# Testimony Submitted to the State Land Use Commission Regarding the Draft Environmental Impact Statement (DEIS) for Hawaii Memorial Park

**SUBJECT:** Hawaiian Memorial Park Cemetery Expansion Project  
Draft Environmental Impact Statement (DEIS)  
TMK: (1) 4-5-033: por. 001 (Private Property)  
Kāneʻohe, Oʻahu, Hawaiʻi

Thank you for your October 23, 2018 email providing comments on the Draft Environmental Impact Statement (DEIS) for the subject project. We have provided responses under numbered subheadings corresponding to your comments (italicized).

Figure 2.5

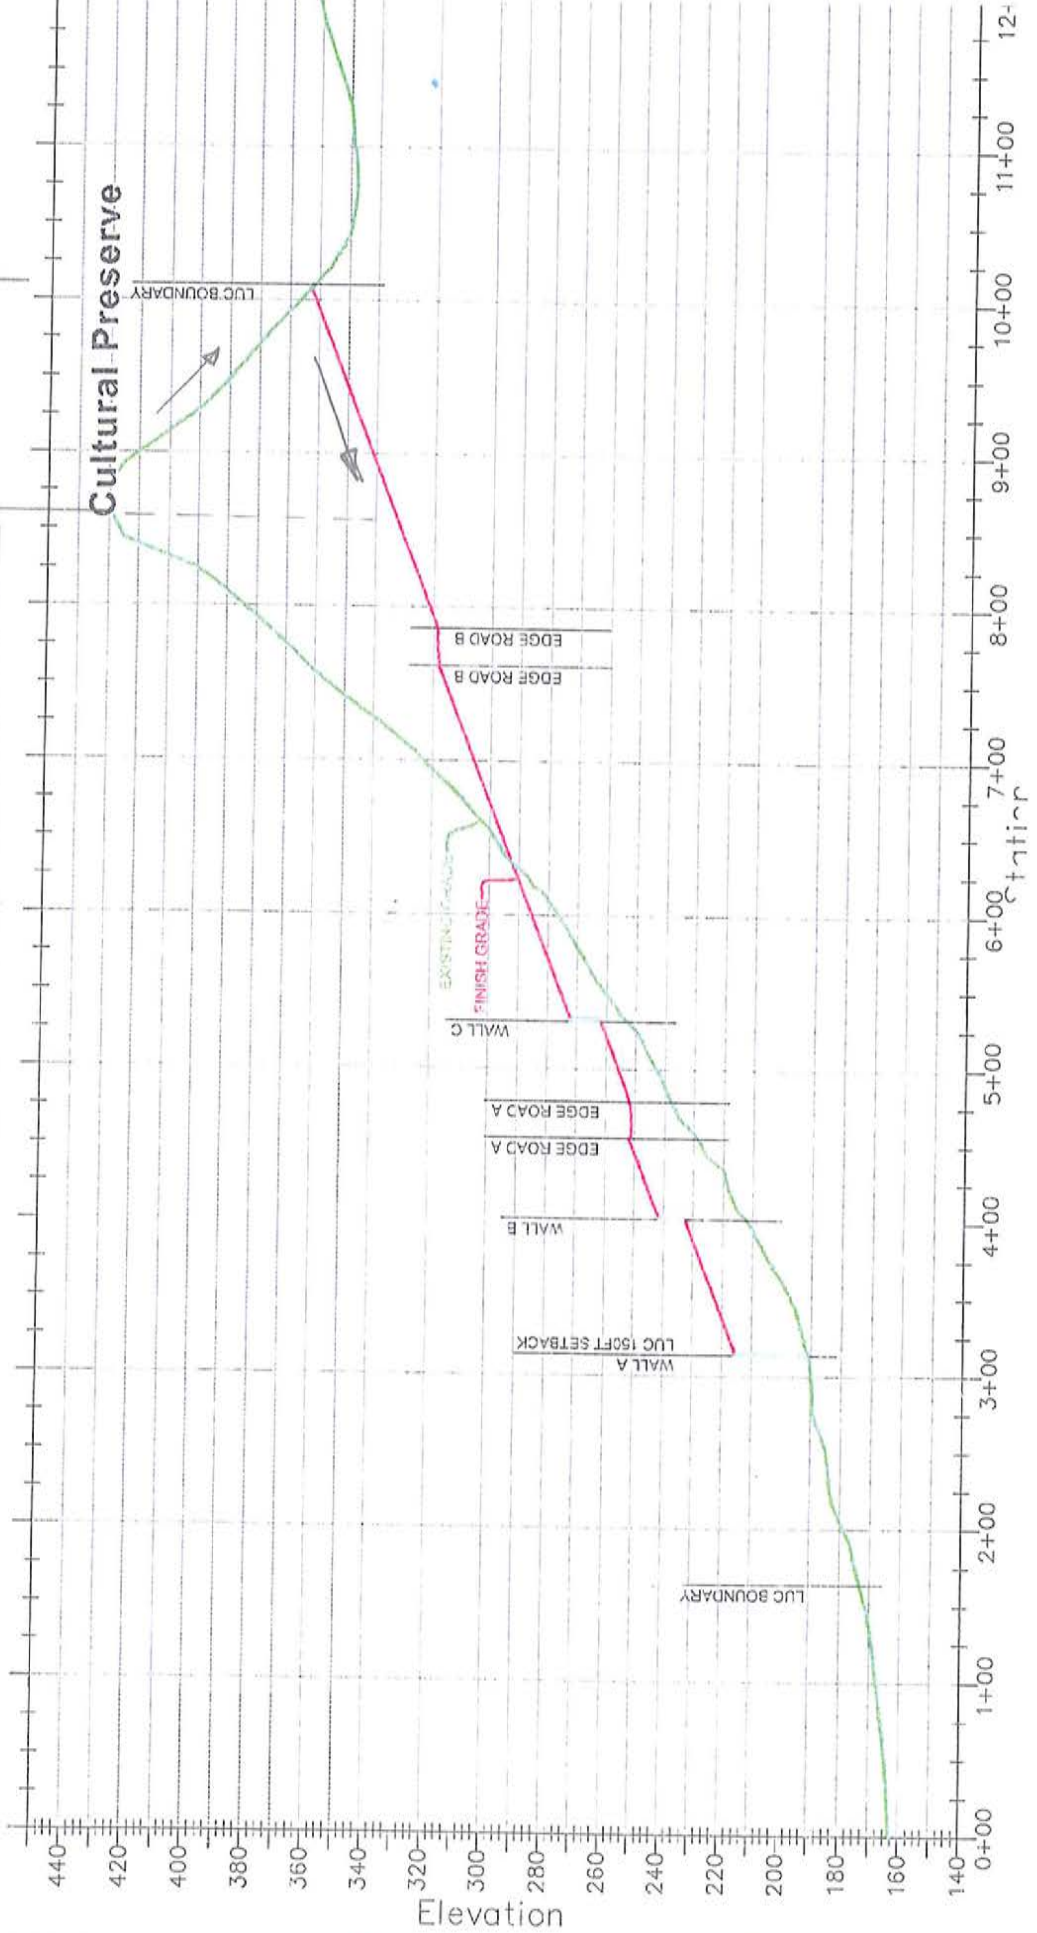
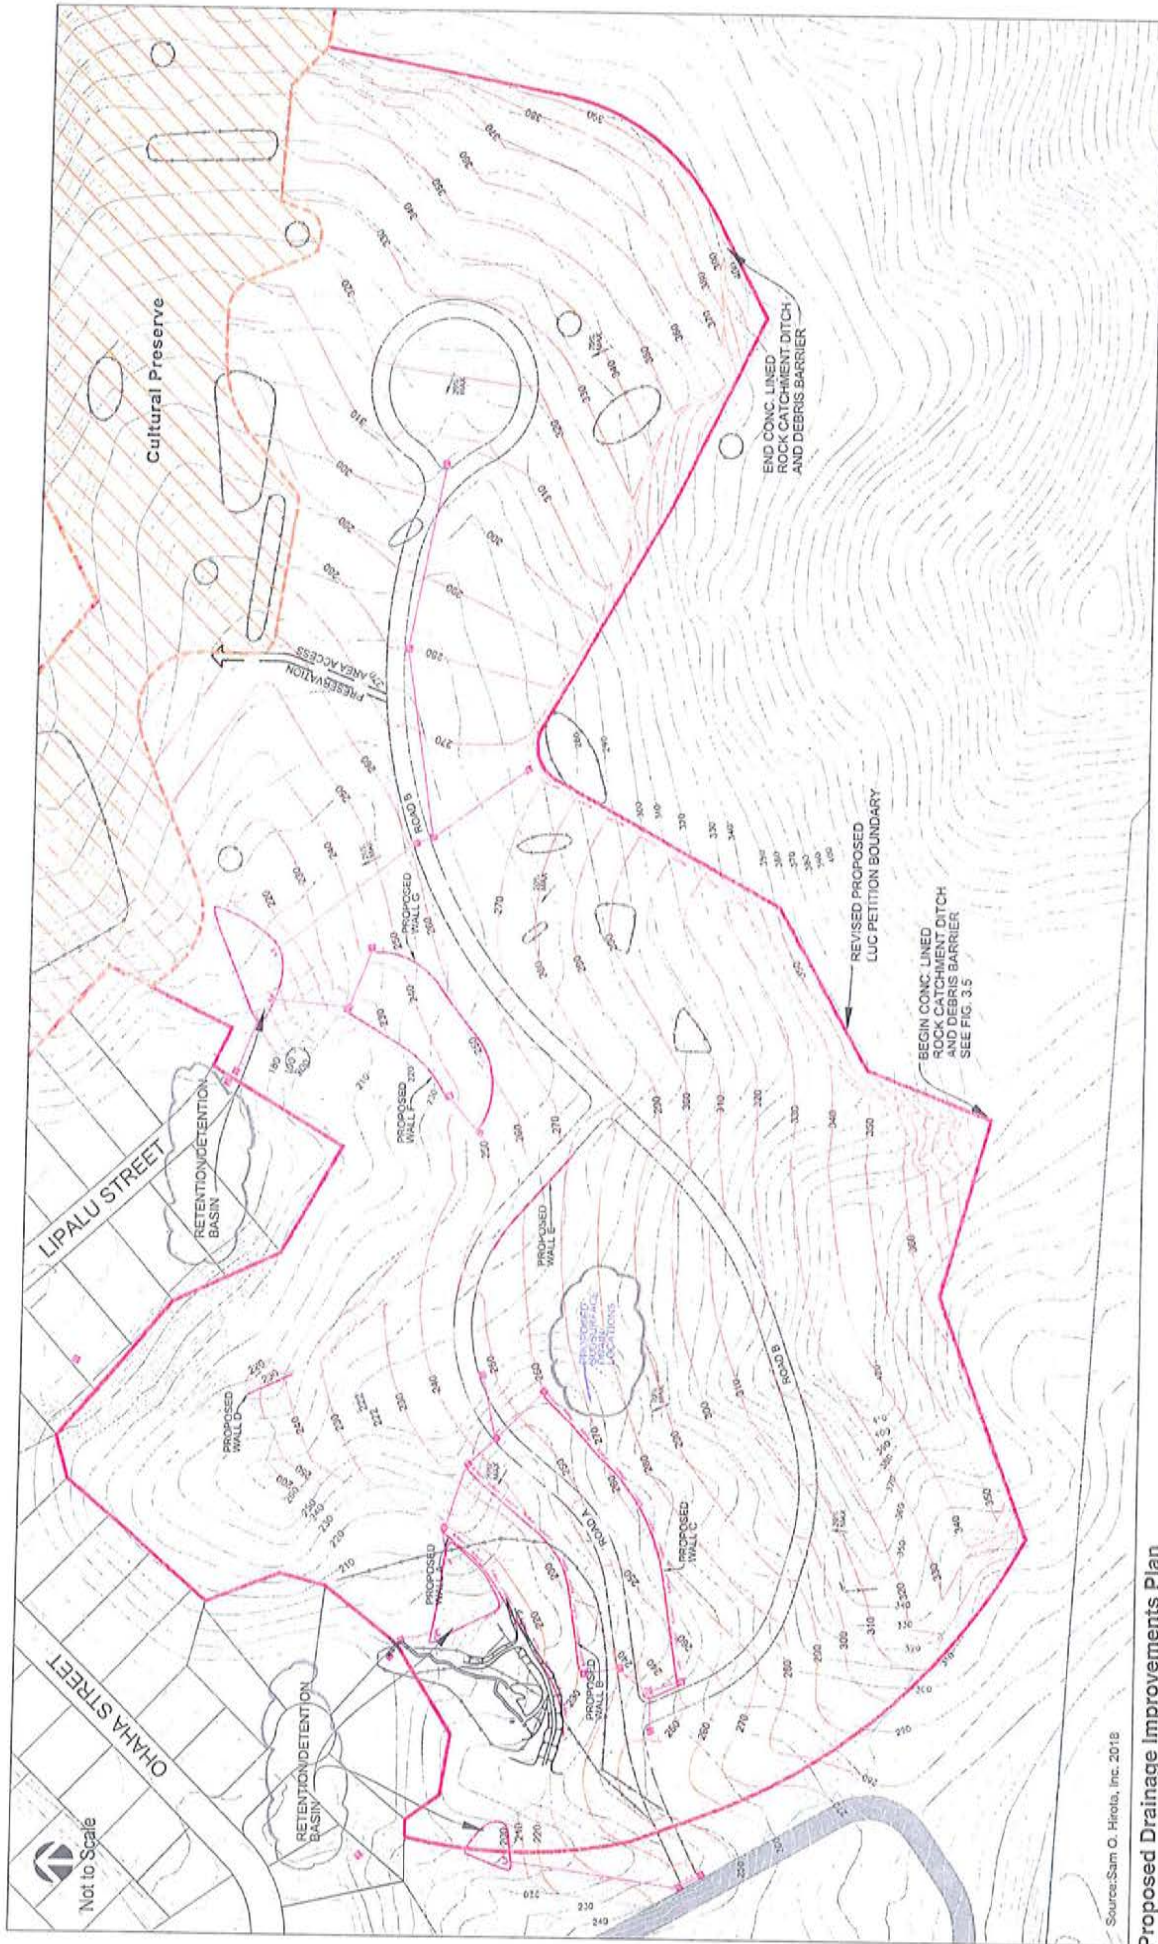
THIS IS THE PORTION OF EXCAVATION WHERE RAIN WATER WOULD FLOW AWAY FROM SUBDIVISION. NOW IT WOULD FLOW TOWARDS THE SUBDIVISION

#### BEFORE

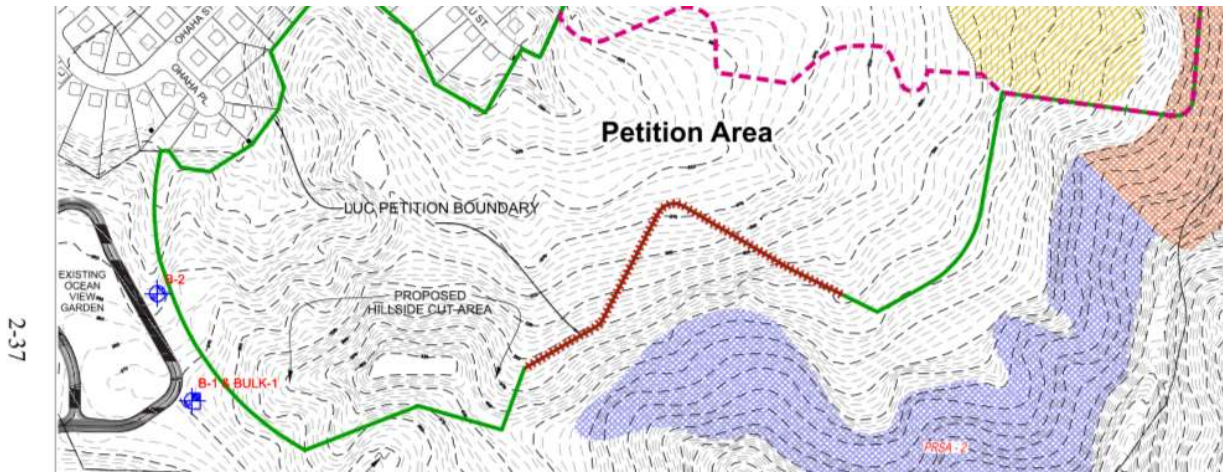
- I believe the visual impacts in the DEIS are not accurately depicted. Could you please include the following to provide a clearer picture of the visual impact to the community:
  - o Rendition of the before and after development from the vantage point included in the original LUC Request.

- o Rendition of the 7 retaining walls against a real photo of the area.
- o Rendition of the far southern border wall, including rockfall pit.

- c. *Rendition of the far southern border wall, including rockfall pit.*  
Response: As previously responded, such a rendering is not necessary because it would not be visible from the public viewing locations identified, and would not influence nor change the results of the visual assessment. The rockfall "pit" consists of a ditch as shown on Exhibit 2.6, and would not be visible from roadways or the Pikoiloa subdivision for the reasons previously discussed.
